Millstone Power Station, Unit No. 1
Licensing Basis Document Change Request (LBD CR) 01-03-2
Fuel Storage Requirements, Technical Specification 4.2

**Licensing Basis Document Change Request (LBDCR) 01-03-2
Fuel Storage Requirements
Evaluation of Proposed Changes and Safety Summary**

PROPOSED TECHNICAL SPECIFICATION CHANGES (MARK-UP)

FIGURE 4.1
MILLSTONE UNIT NO. 1 SPENT FUEL POOL

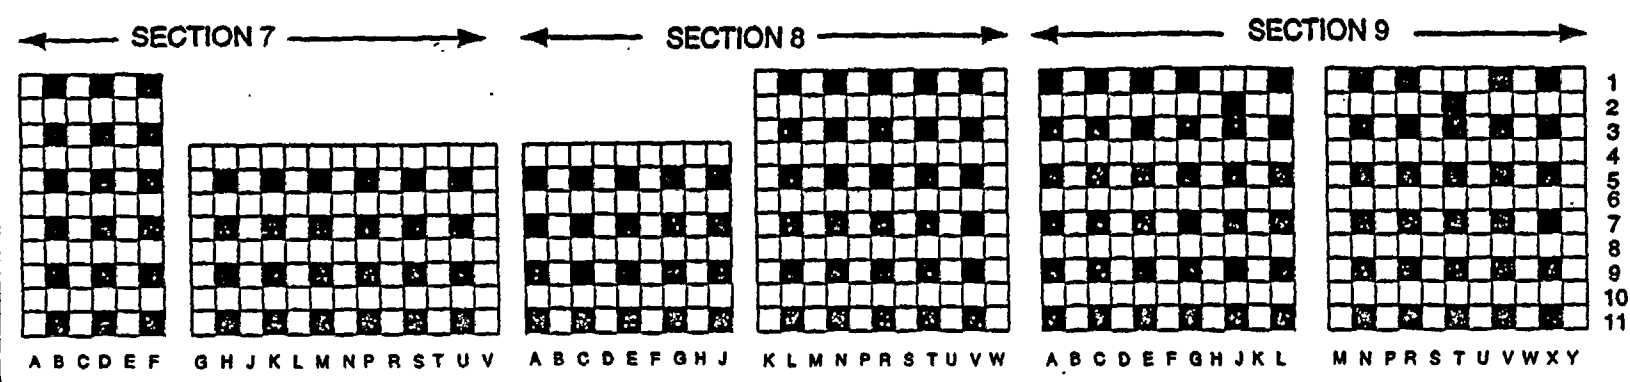
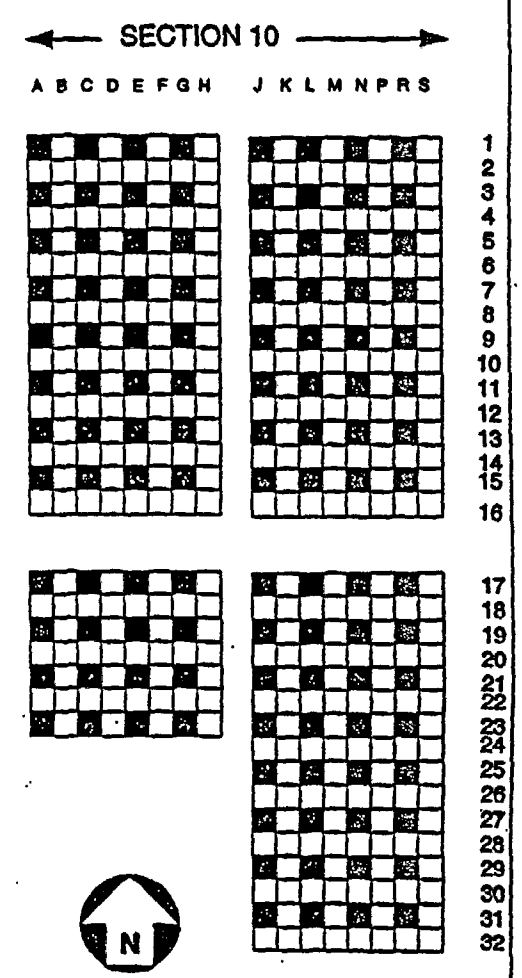
- Section 4.2.2 is proposed to have three changes. The first is to change the required k_{eff} from 0.90 to 0.95. The second change is to add the phrase "and with no fuel allowed in the storage locations shown in Figure 4.1." The third change is to add Figure 4.1.

Add this page

■ NO FUEL ALLOWED IN THESE STORAGE LOCATIONS

4.2.2 The K_{eff} of the spent fuel storage pool shall be less than or equal to 0.95 ← 0.90. This K_{eff} value is satisfied with fuel assemblies having a maximum k-infinity of 1.24 in the normal reactor configuration at cold conditions, and an average U-235 enrichment of 3.8 weight percent or less, and with no fuel allowed in the storage locations shown in Figure 4.1.

FIGURE 4.1
MILLSTONE UNIT NO. 1 SPENT FUEL POOL

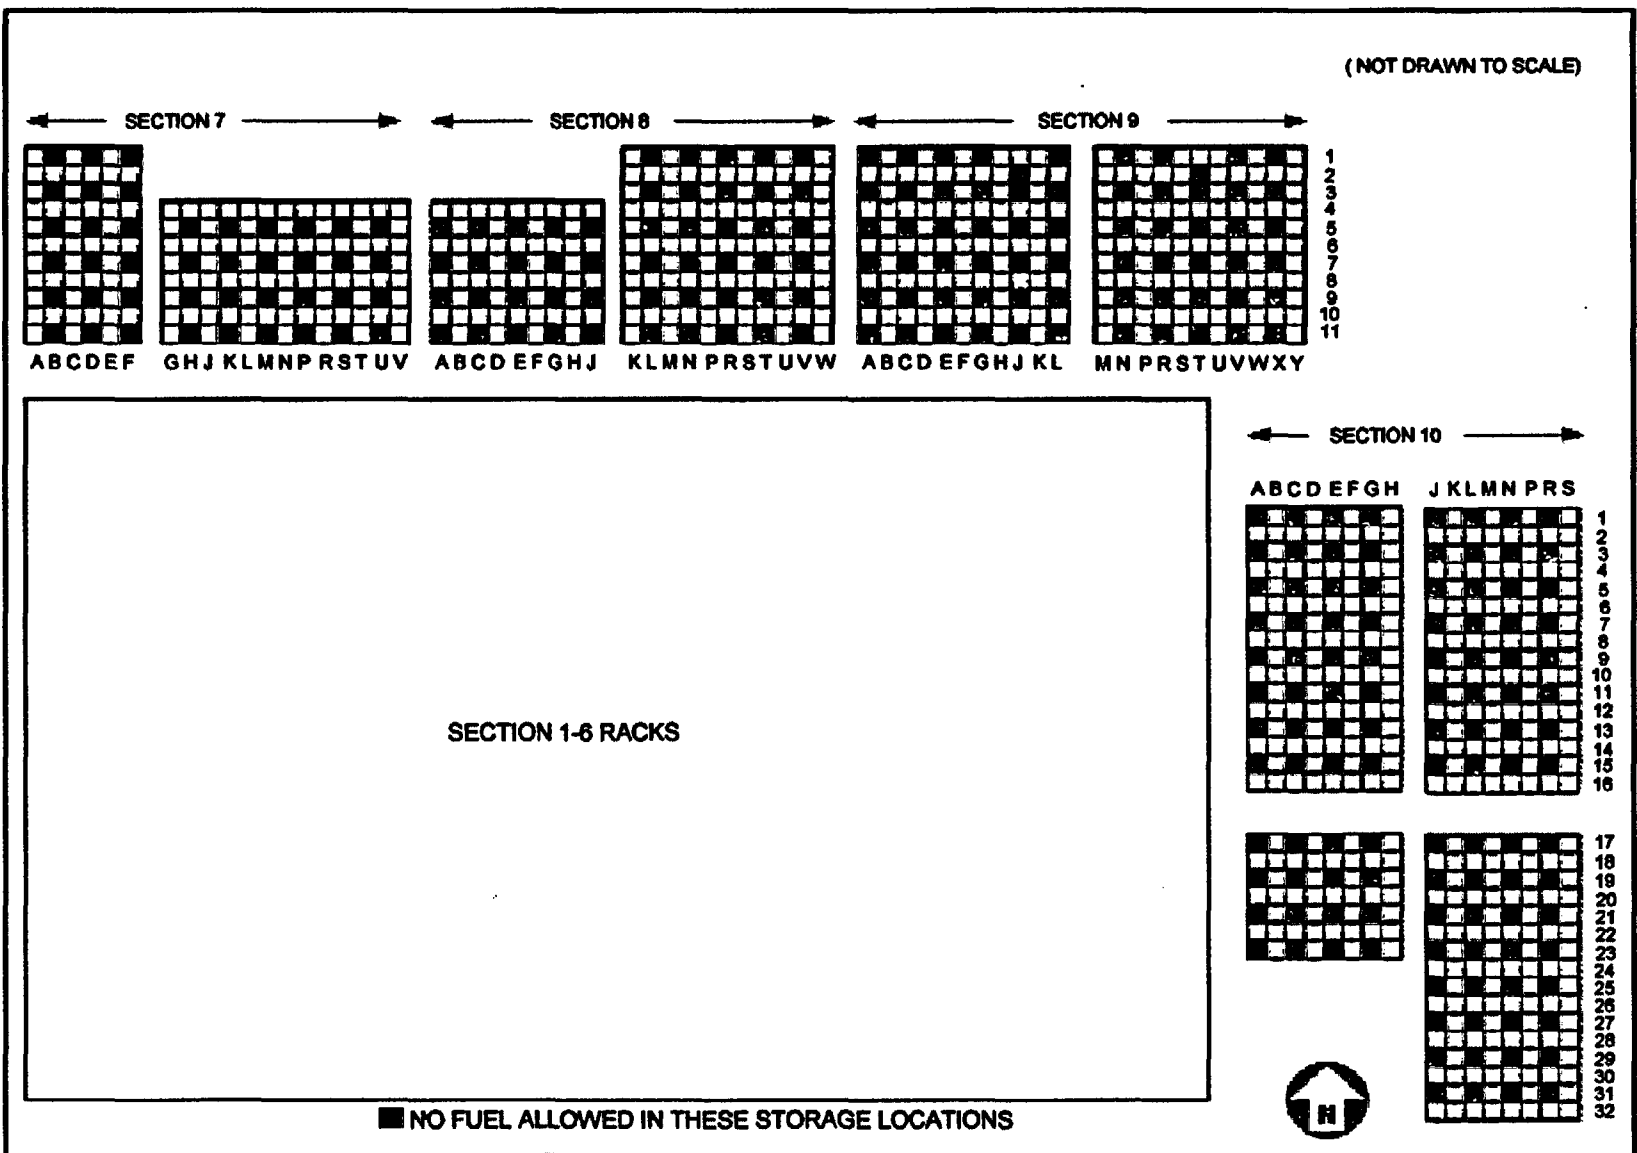
Proposed Technical Specification Figure 4.1 shows the required 3-out-of-4 fuel storage pattern to ensure that the criticality analysis remains valid. As shown in Figure 4.1, spent fuel pool locations 9-1-J and 9-1-T allow fuel storage, and spent fuel pool locations 9-2-J and 9-2-T do not allow fuel storage. These locations do not have the repeating 3-out-of-4 pattern that is evident in the other Boraflex rack locations. This was necessary to avoid moving the 2 fuel assemblies from spent fuel pool locations 9-1-J and 9-1-T. It is difficult to move fuel from these 2 locations due to wall interferences. As a result, it was verified by additional KENOva calculations that spent fuel pool locations 9-2-J and 9-2-T are adequate substitutes as "non-fuel" locations, instead of spent fuel pool locations 9-1-J and 9-1-T. KENOva calculations performed by Dominion Nuclear Connecticut, Inc. (DNC) confirmed that there was no adverse effect due to this change.

4.2.2 The K_{eff} of the spent fuel storage pool shall be less than or equal to 0.95. This K_{eff} value is satisfied with fuel assemblies having a maximum k-infinity of 1.24 in the normal reactor configuration at cold conditions, and an average U-235 enrichment of 3.8 weight percent or less, and with no fuel allowed in the storage locations shown in Figure 4.1.
